**Modification/Change Order No. 2**

EWP – Cane Island Branch of Buffalo Bayou Channel Bank Stabilization Phase V

Fort Bend County, Texas

Modification/Change Order No.2  
 EWP - Cane Island Branch of Buffalo Bayou Channel Bank Stabilization Phase 5  
 PO # 189196  
 Solicitation No. B20-079  
 Fort Bend County, Texas  
 October 29, 2020

DRAWING NO. TX-EN-0789  
 SHEET NO. 6  
 OF 16

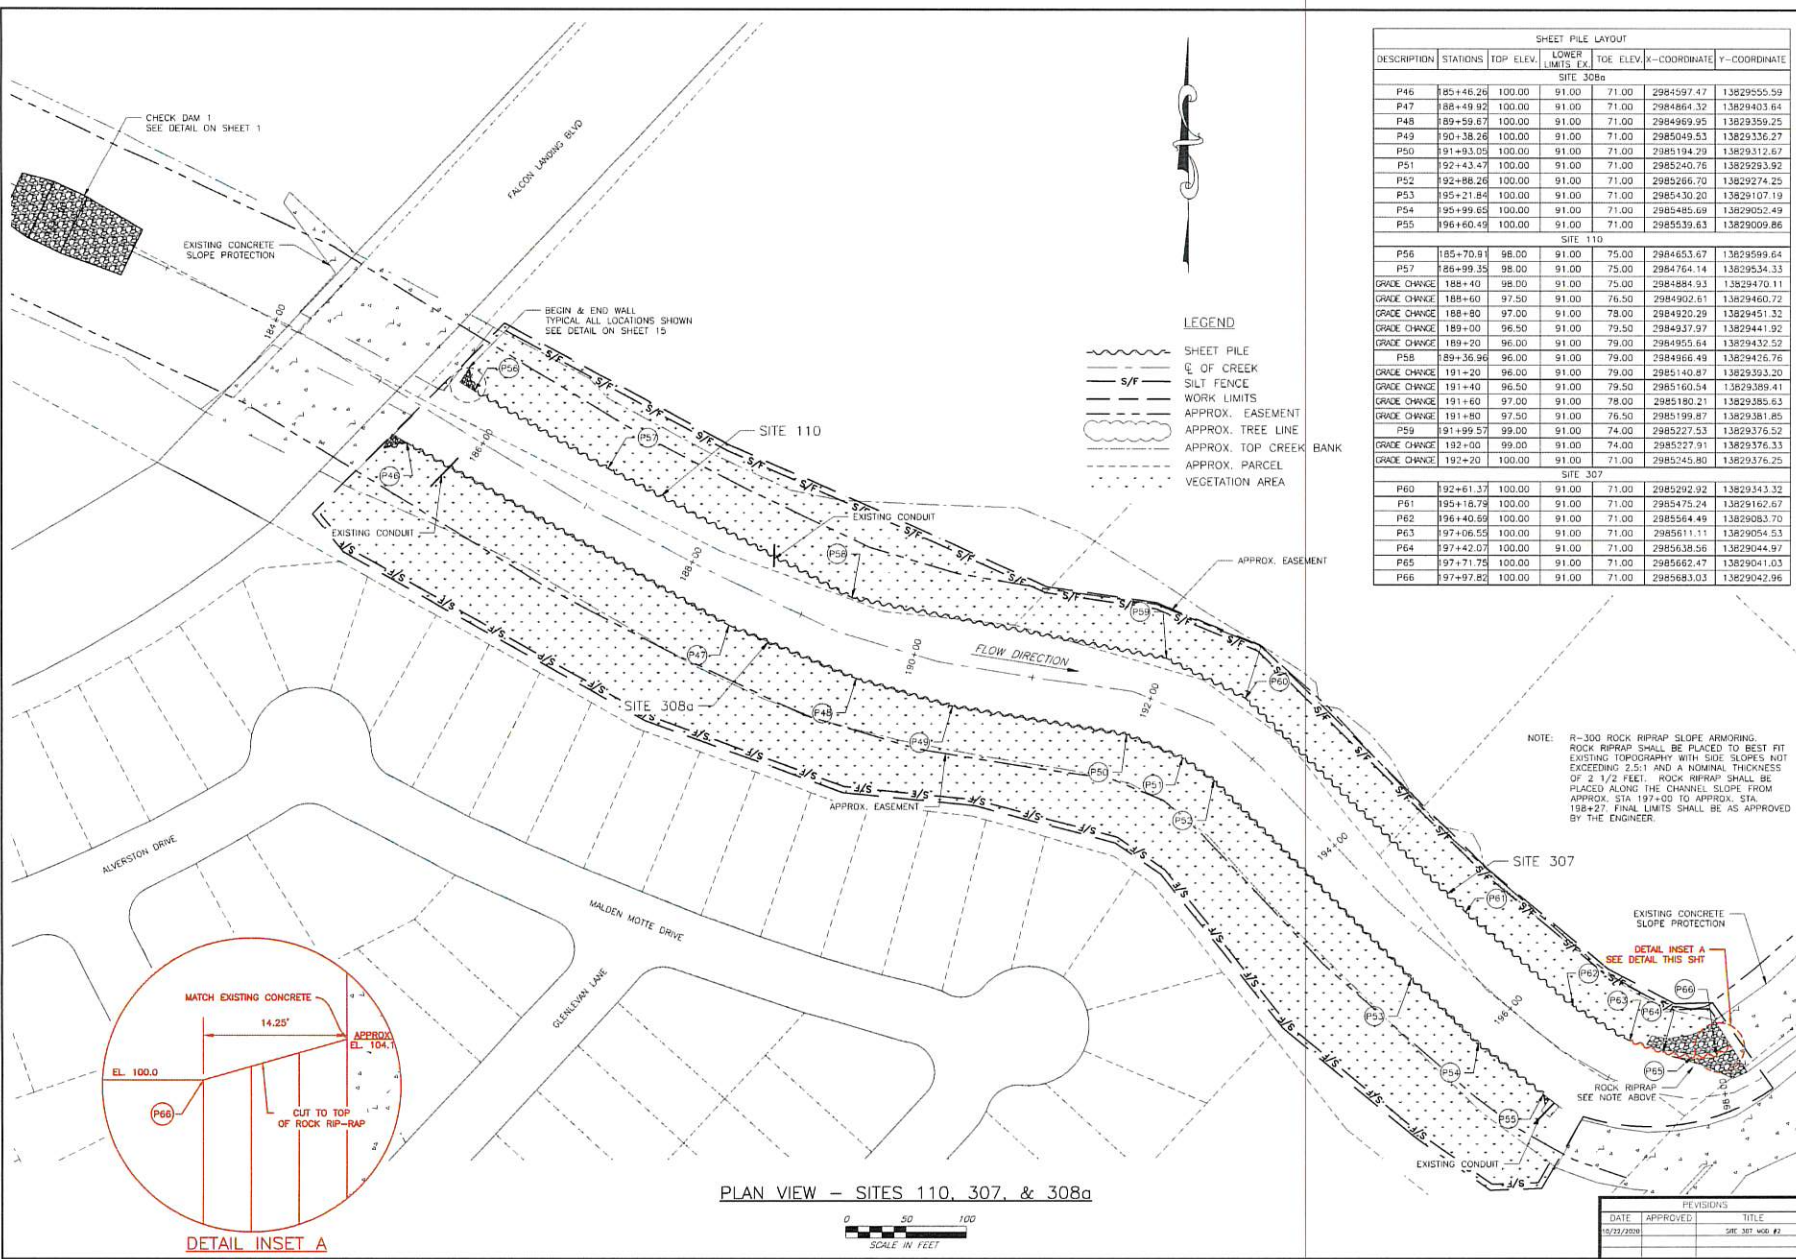
3. The steel Sheet pile walls on Site 307 shall be modified as shown on the attached revised Drawing TX-EN-0789 Sheet 6, Change Order 2. The Contractor shall furnish and install all required anchors, waler, jet filters and fine and coarse drainfill as specified for steel sheet pipe walls placed. Compensation shall be in accordance with the applicable added items below and measurement shall be in accordance with the contract specified methods. Contractor Quality Control shall be accomplished in accordance with Construction Specification 94 for the added work.

4. The Contractor shall install furnished drain material provided by Fort Bend County Drainage District and adjust steel sheet pile wall in accordance with the drawings on Site 307.
